**STAFF RECOMMENDATION**  
**2121 Blair Boulevard**  
**September 19, 2018**

**Application:** New Construction - Addition; Setback Determination  
**District:** Hillsboro-West End Neighborhood Conservation Zoning Overlay  
**Council District:** 18  
**Map and Parcel Number:** 10415017700  
**Applicant:** Candis Carroll  
**Project Lead:** Sean Alexander, sean.alexander@nashville.gov

ELEVATIONS

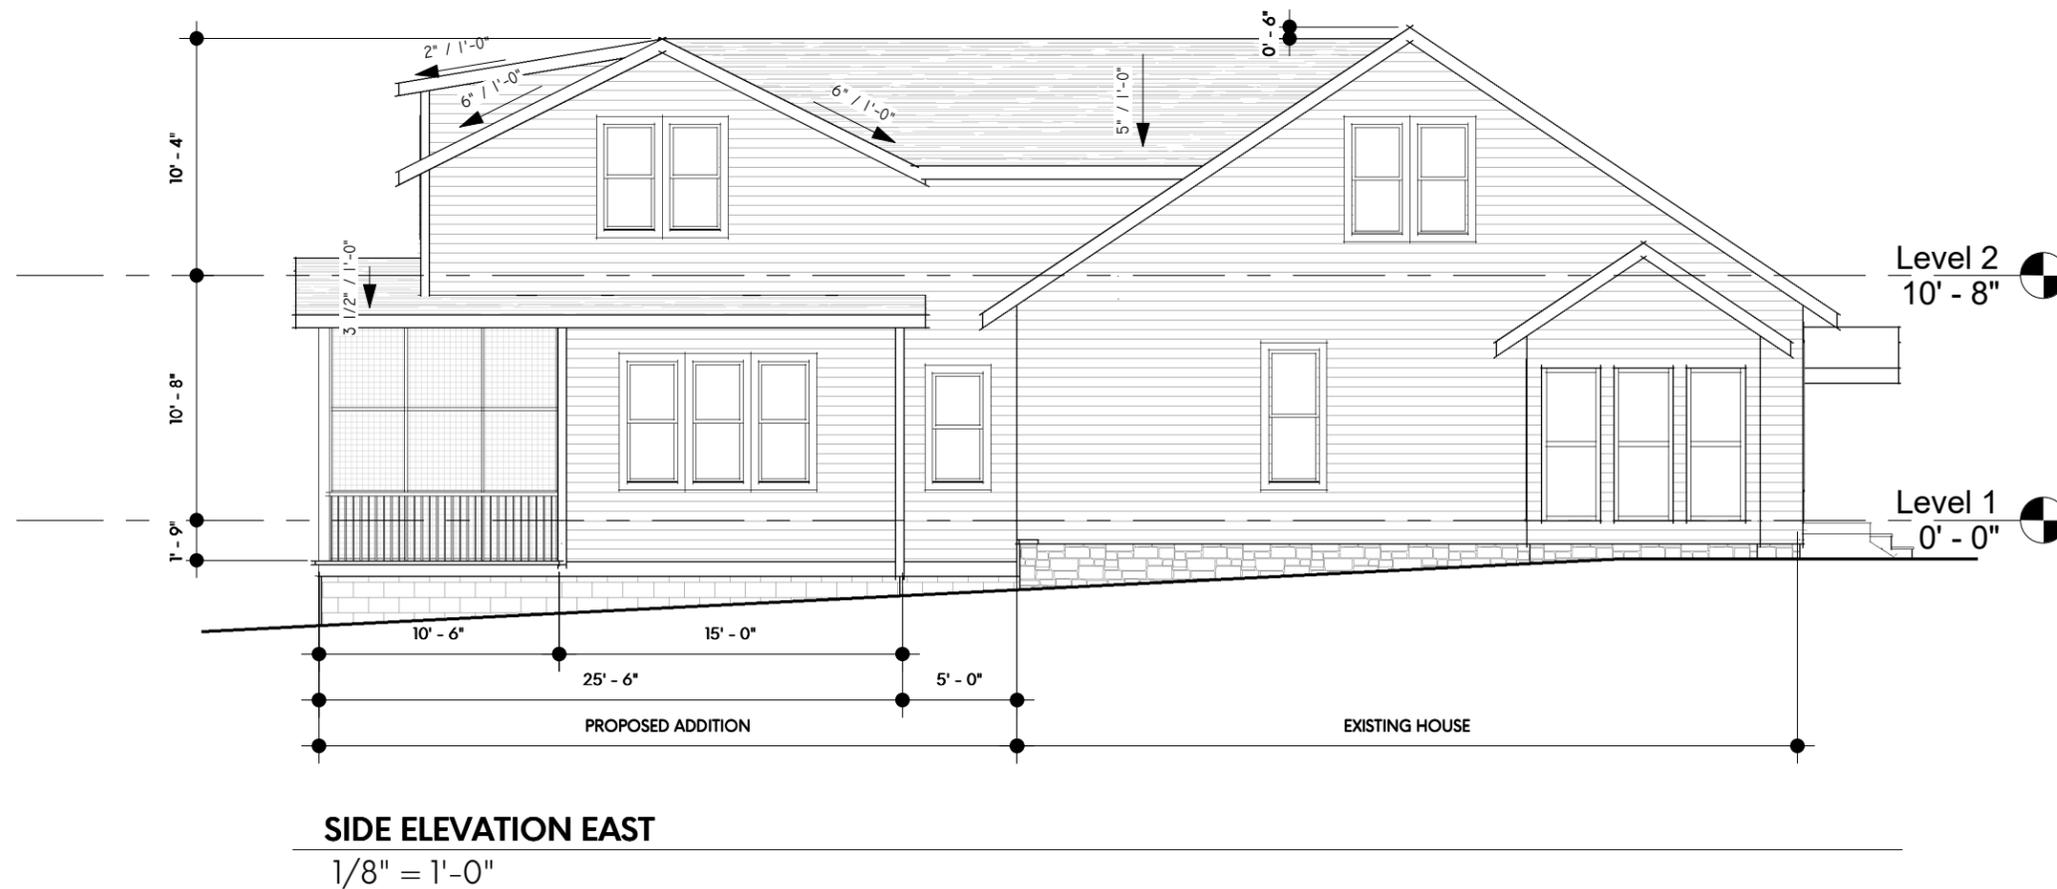
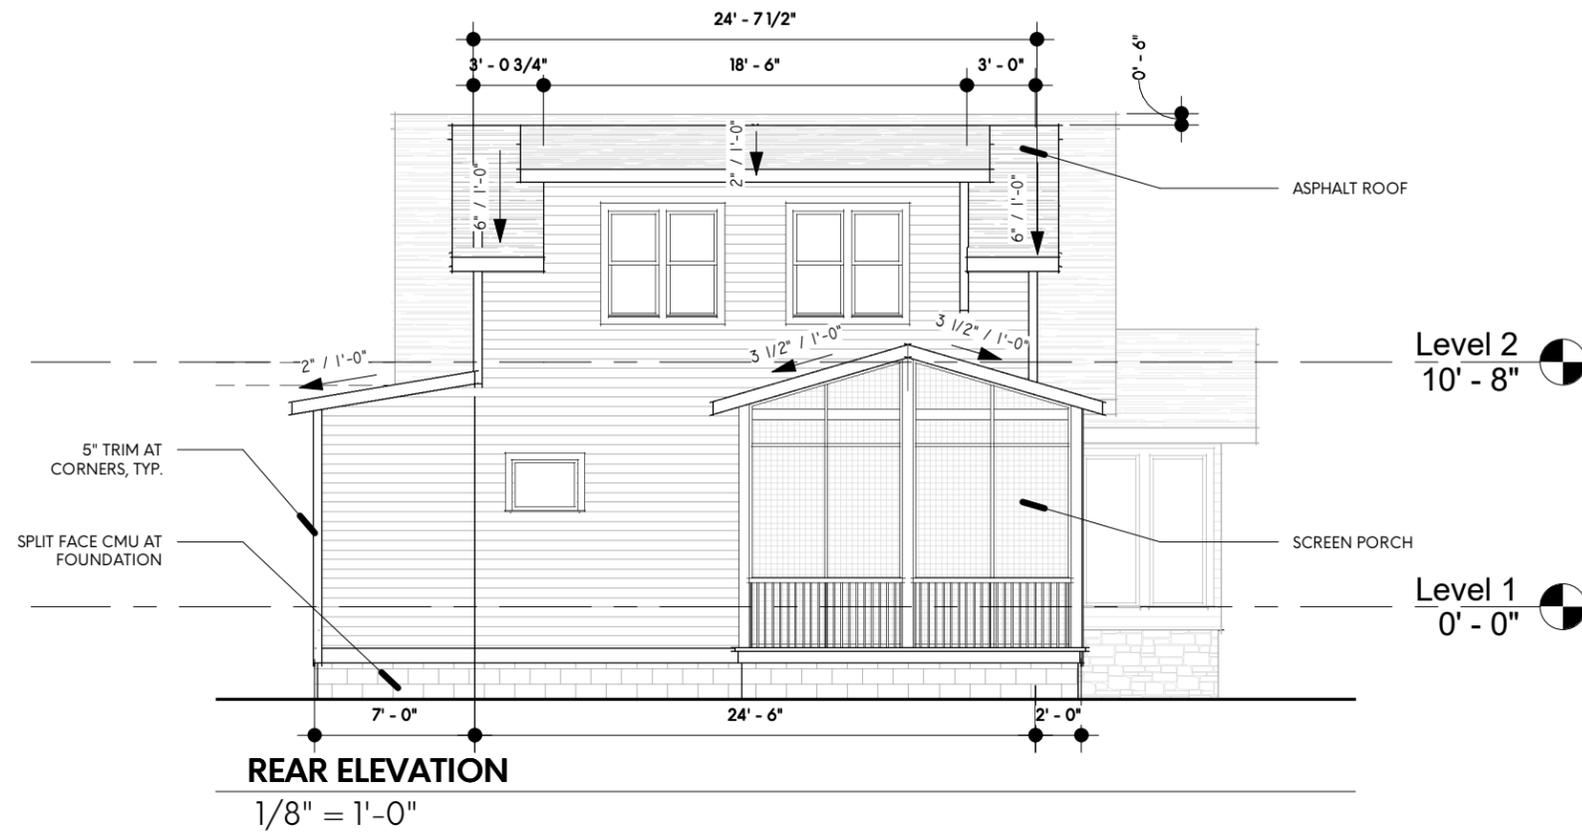
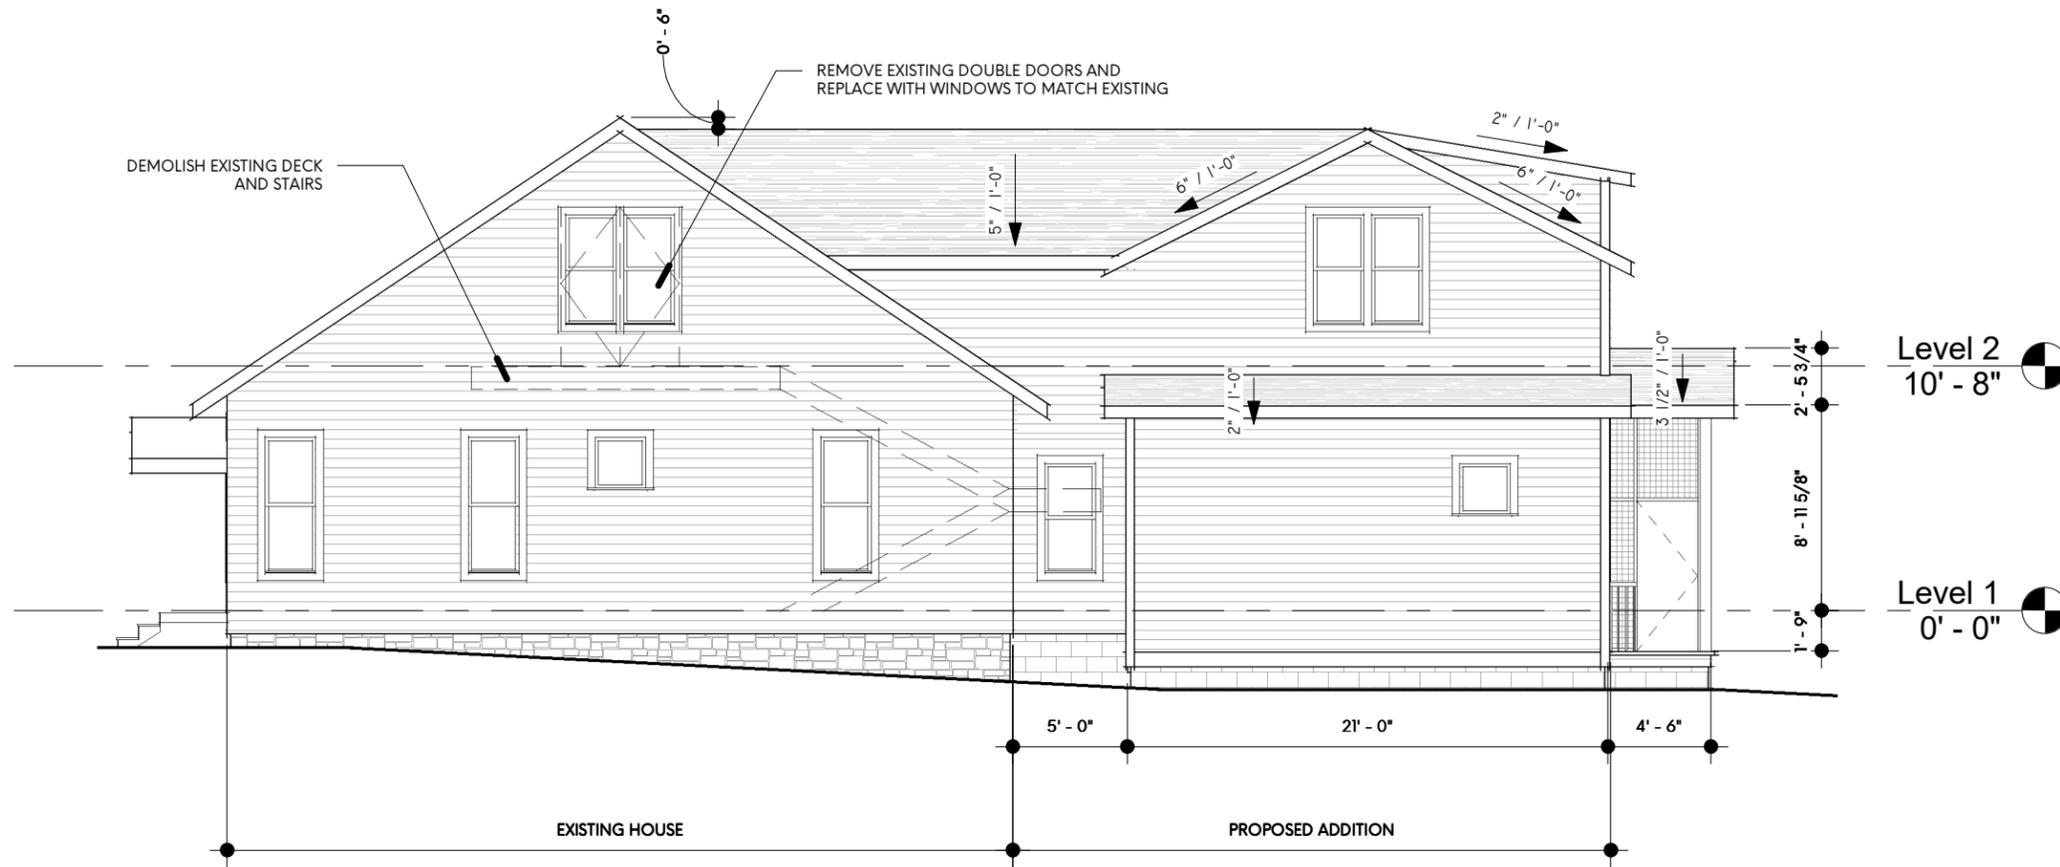
The roof of the addition will tie in to the historic house's roof ridge with a rear-oriented cross gable, matching the height of existing roof. The two-story component of the addition will have an eave height seven feet (7') higher than the house's primary eave height, but the higher eaves will not read as having a larger scale than the house because they are stepped in two feet (2') on both sides. This will help keep the massing of the addition from appearing larger than that of the original building.

Roof form: The addition's roof will be a rear-oriented cross-gable, tying in to the rear of the existing roof at the ridge. The pitch of the new second story gable will be 6:12, which is lower than the original roof's 8:12 pitch but not so different as to be visually disrupting. The wider one story sections will have shed roofs with a 2:12 pitch. These roofs are not unlike those on similar small side projections on historic houses nearby. Staff finds the roofs of the proposed addition meet section II.B.1.e of the design guidelines.

Proportion and Rhythm of Openings: The windows on the left side and both upperstory facades of the proposed addition are to be vertically oriented, with no large expanses of wallspaces between openings, which is in keeping with the window patterns on historic houses. The wider one story projection on the right side will have only a single square window toward the rear. Because of its location the visibility of this window will be minimal and will not contrast greatly with the historic house. Staff finds the project's proportion and rhythm of openings will meet section II.B.1.g of the design guidelines.
